Department of Parks, Recreation and Waterfront
Waterfront Capital Improvements Program Division

March 7, 2024

**CITY OF BERKELEY
BERKELEY MARINA DOCKS D & E REPLACEMENT
SPEC. NO. 24-11633-C**

ADDENDUM NO. 2

BERKELEY MARINA DOCK REPLACEMENT (D-E)
CITY OF BERKELEY, ALAMEDA COUNTY, CALIFORNIA
DEMOLITION
SHEET 2 OF 2

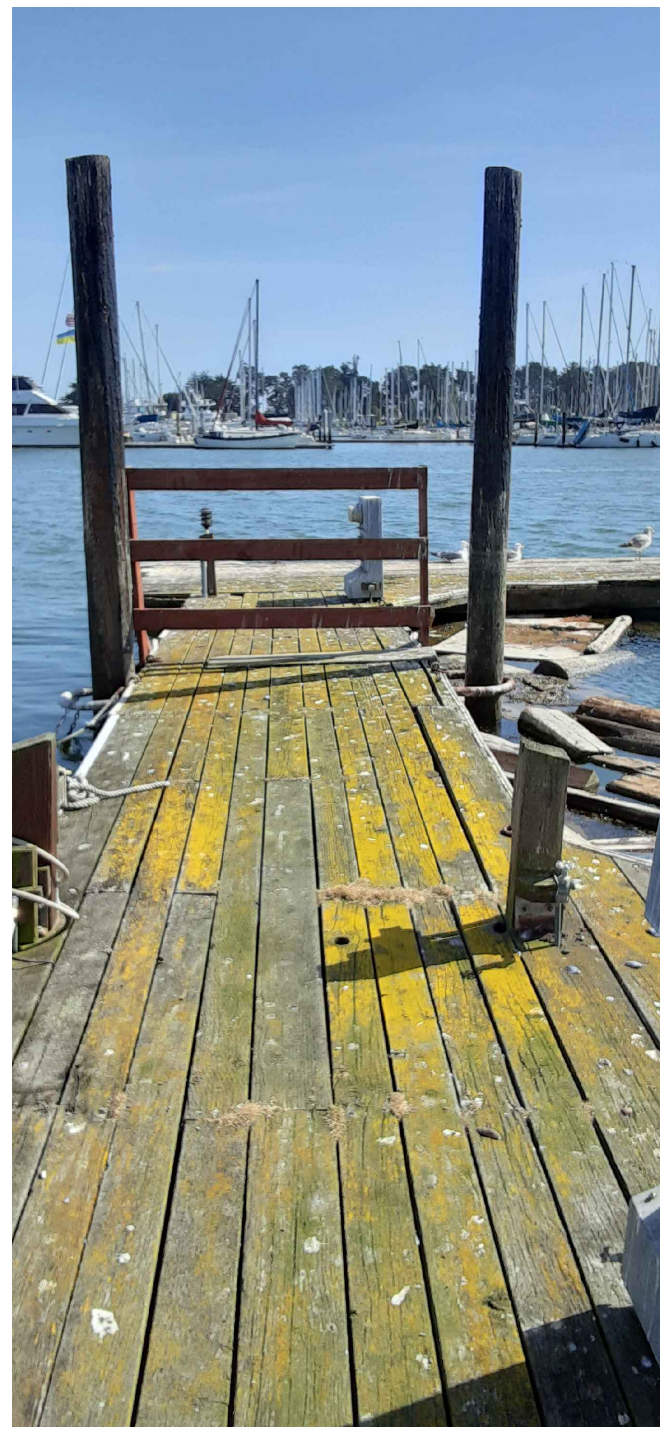
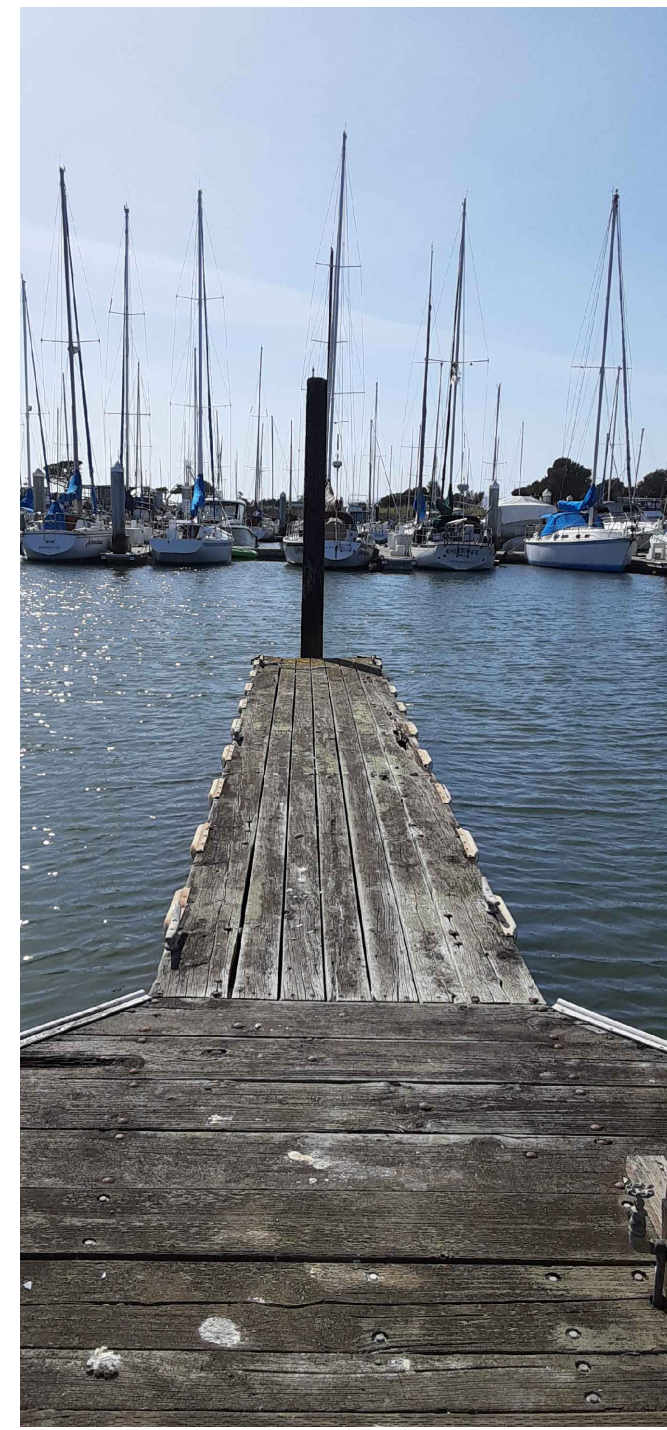
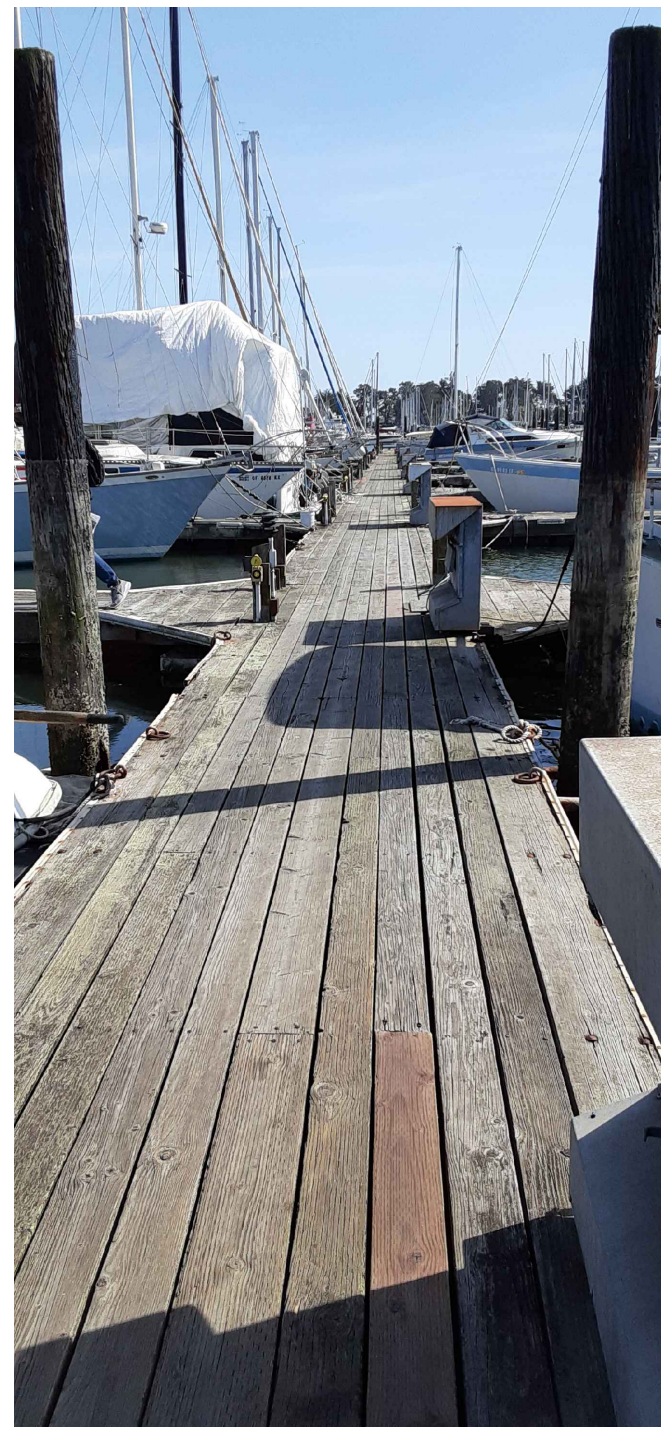
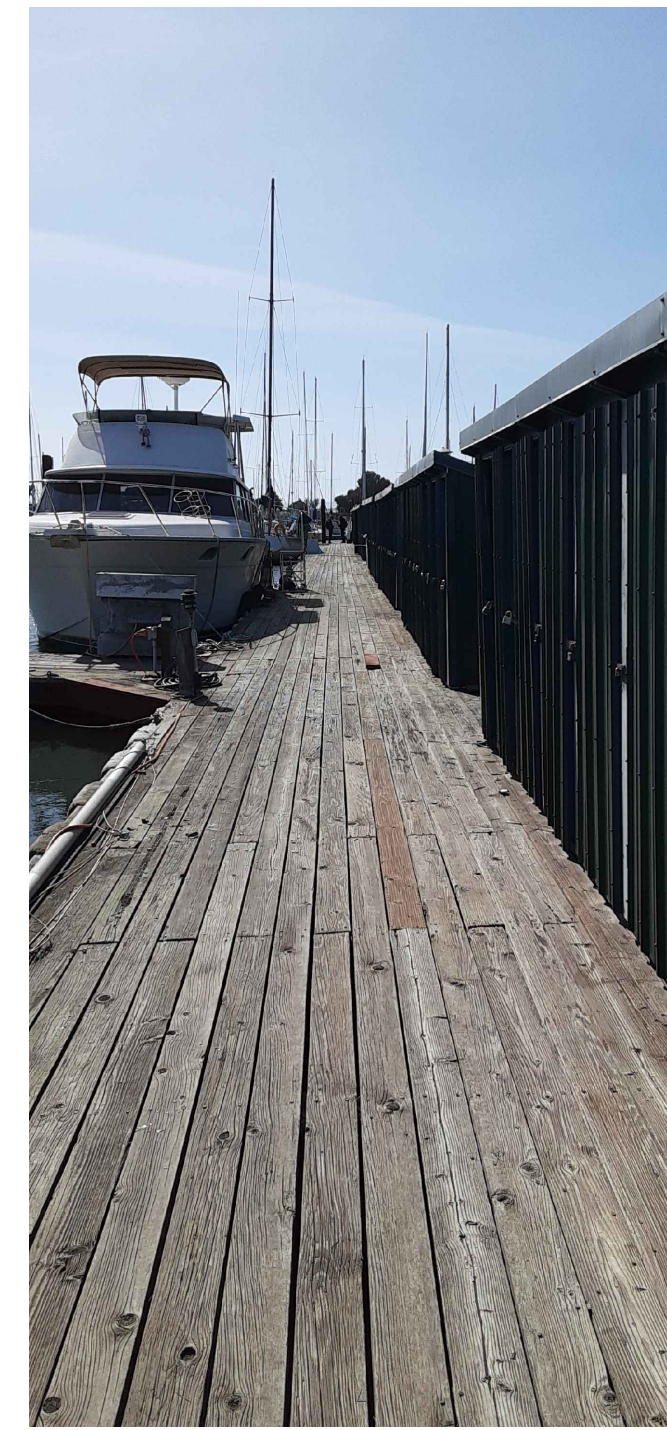
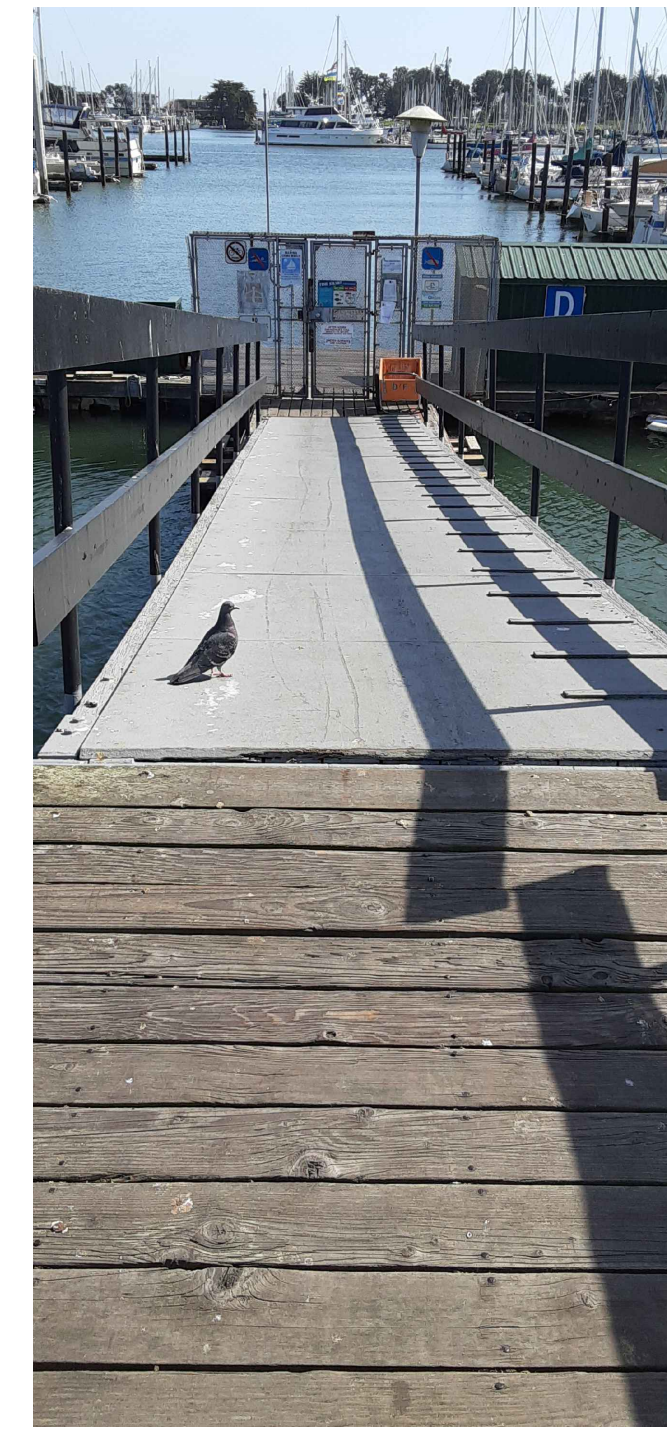
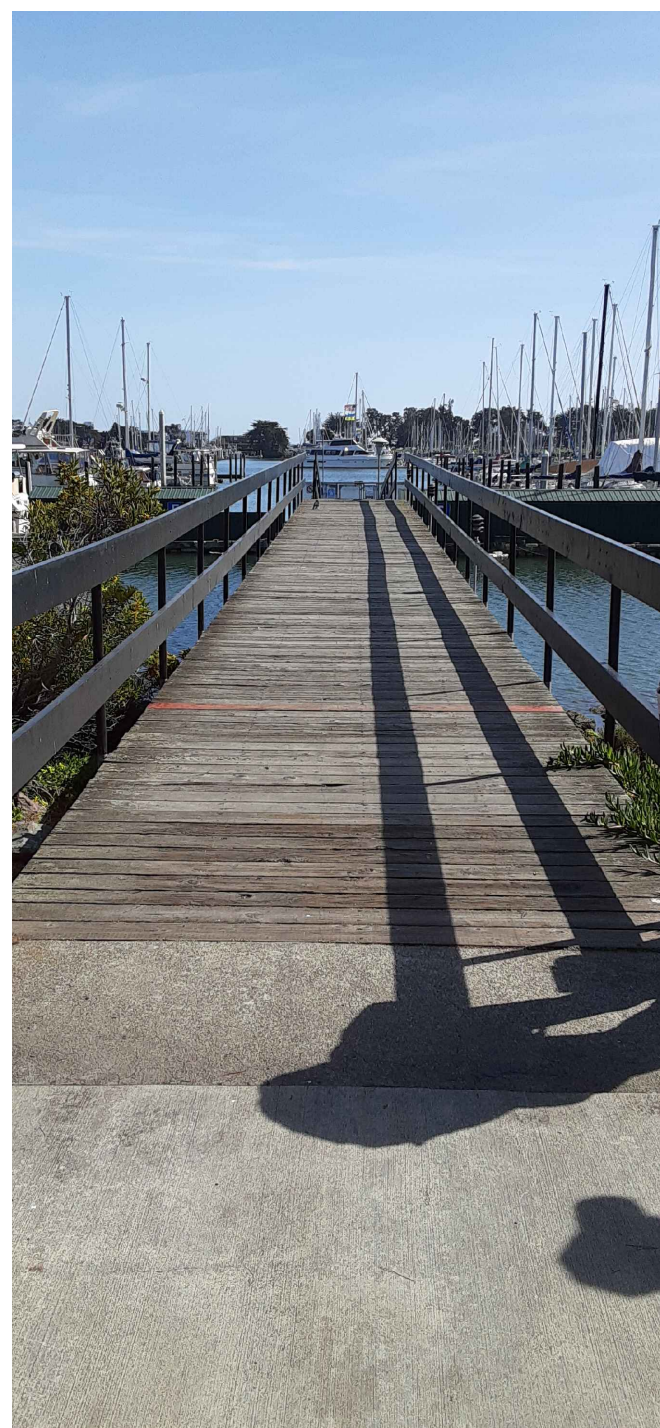
- New photo of piles to be removed to include concrete precast pile.
5. **Plans:** Sheet C-100, Landside Improvement Plan
REPLACE with attached revised Sheet C-100

60. On the site walk, we observed at least two concrete piles in the marine demolition footprint that are not identified on the plans. Please clarify if these are intended to be removed as part of the demolition scope and if so, identify location and quantity.

Response: Total of 3 precast concrete piles to be removed and disposed of. See attached revised drawings D-100 and D-101 for locations.
